SERVICE INSTRUCTIONS

No. 1166
ATA Code 32-10

- SUBJECT:** LANDING GEAR - INSTALLATION OF IMPROVED MAIN LANDING GEAR DOORS
- EFFECTIVITY:** BEEHCRAFT Duchess 76, serials ME-1 through ME-347.
- REASON:** To install improved main landing gear doors and attaching hardware.
- COMPLIANCE:** Beech Aircraft Corporation considers this to be a mandatory modification and it should be accomplished as soon as possible after receipt of these Service Instructions, but no later than the next 100 service hours.
- APPROVAL:** FAA Approved.
- MANPOWER:** The following information is for planning purposes only:

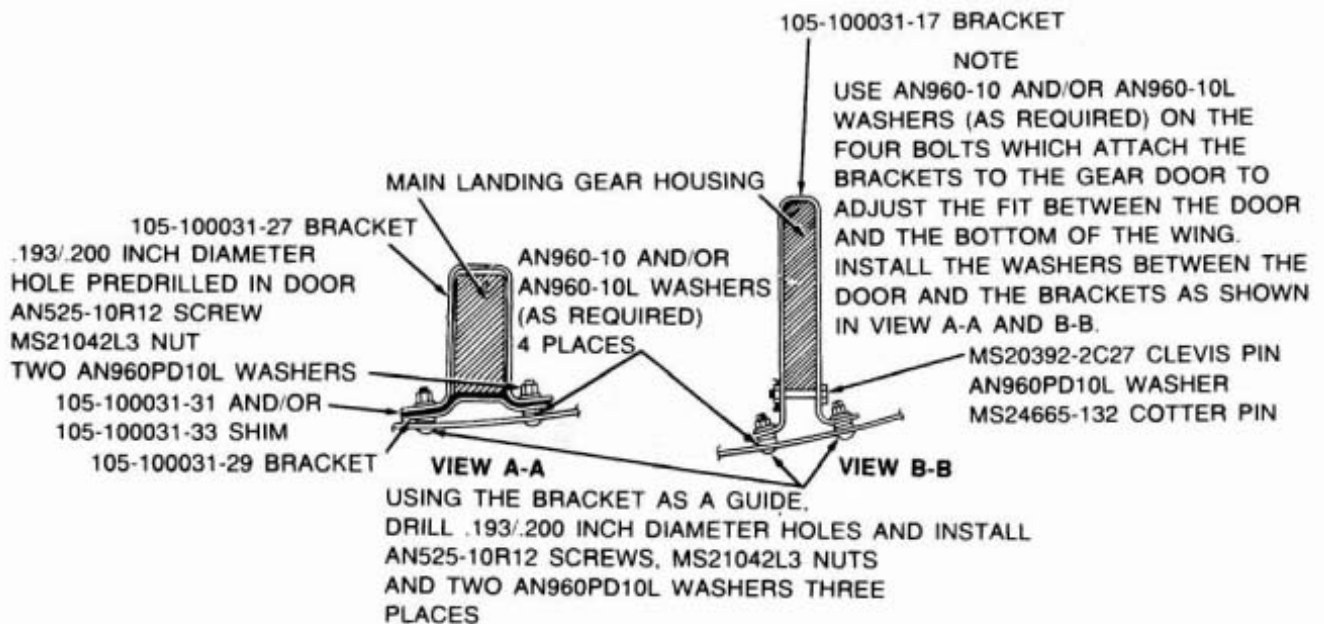
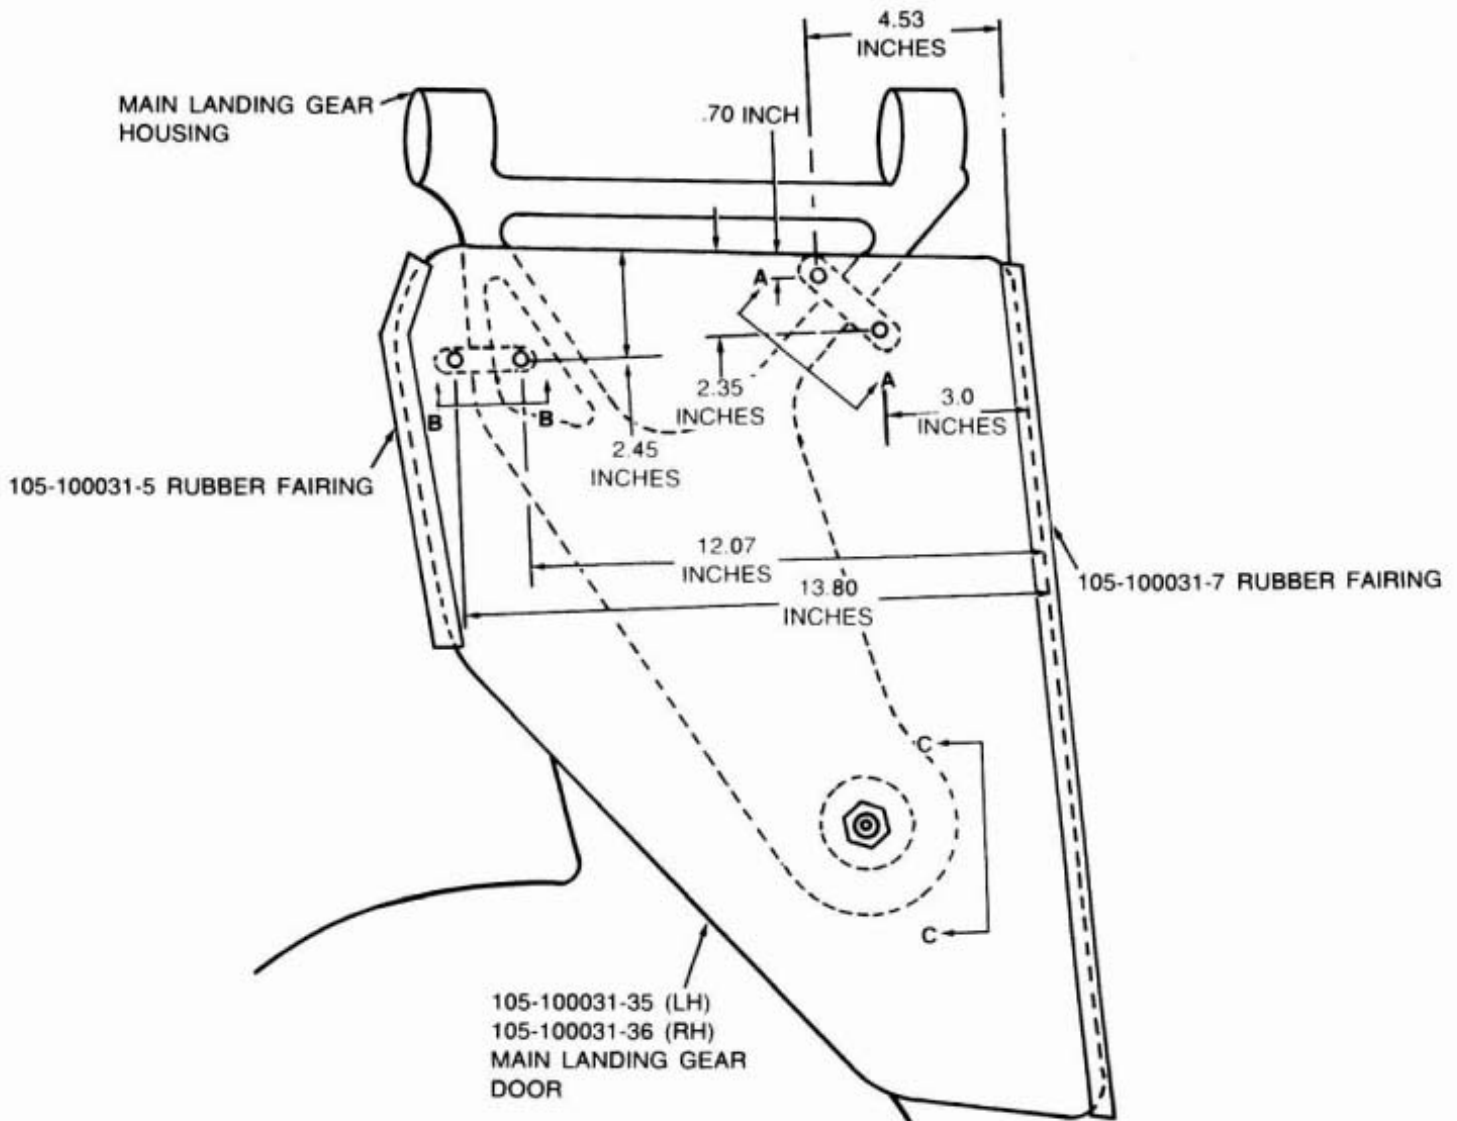
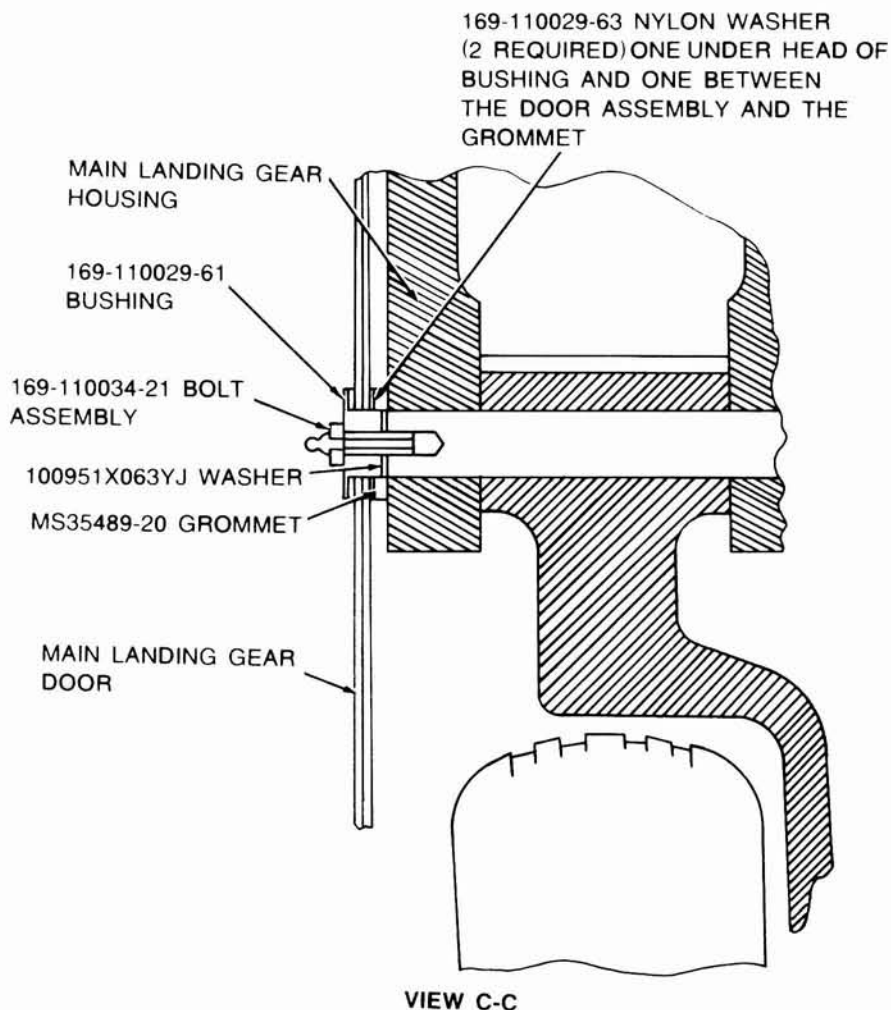
2. Position a new P/N 105-100031-35 (LH) or P/N 105-100031-36 (RH) main landing gear door on the main landing gear housing and install a new P/N 100951X063YJ washer, P/N MS35489-20 grommet, P/N 169-110029-61 bushing, two P/N 169-110029-63 nylon washers and P/N 169-110034-21 bolt assembly as shown in view C-C of the illustration.

3. Position a P/N 105-100031-27 bracket, P/N 105-100031-29 bracket and P/N 105-100031-31 and/or P/N 105-100031-33 shims (as required) on the main landing gear door and housing as shown in view A-A of the illustration.

4. Temporarily secure the bracket assembly using the predrilled hole in the door and the hardware shown in view A-A of the illustration.

5. Drill the other .193/200 inch diameter hole through the main landing gear door using the bracket assembly as a guide as shown in view A-A of the illustration.

6. Attach the P/N 105-100031-27 bracket, P/N 105-100031-29 bracket and P/N 105-100031-31 and/or P/N 105-100031-33 shims (as required) to the main landing gear door using the hardware specified in view A-A of the illustration.

7. Position the P/N 105-100031-17 bracket on the main landing gear door and housing as shown in view B-B of the illustration and drill two .193/200 inch diameter holes through the door using the bracket as a guide.

8. Attach the P/N 105-100031-17 bracket to the main landing gear door using the hardware specified in view B-B of the illustration.

9. Install a P/N MS20392-2C27 clevis pin, AN960PD10L washer and MS24665-132 cotter pin through P/N 105-100031-17 bracket as shown in view B-B of the illustration.

11. Install a new P/N 105-100031-5 aft rubber fairing and P/N 105-100031-7 forward rubber fairing on the main landing gear door as shown in the illustration with EC1300L adhesive.
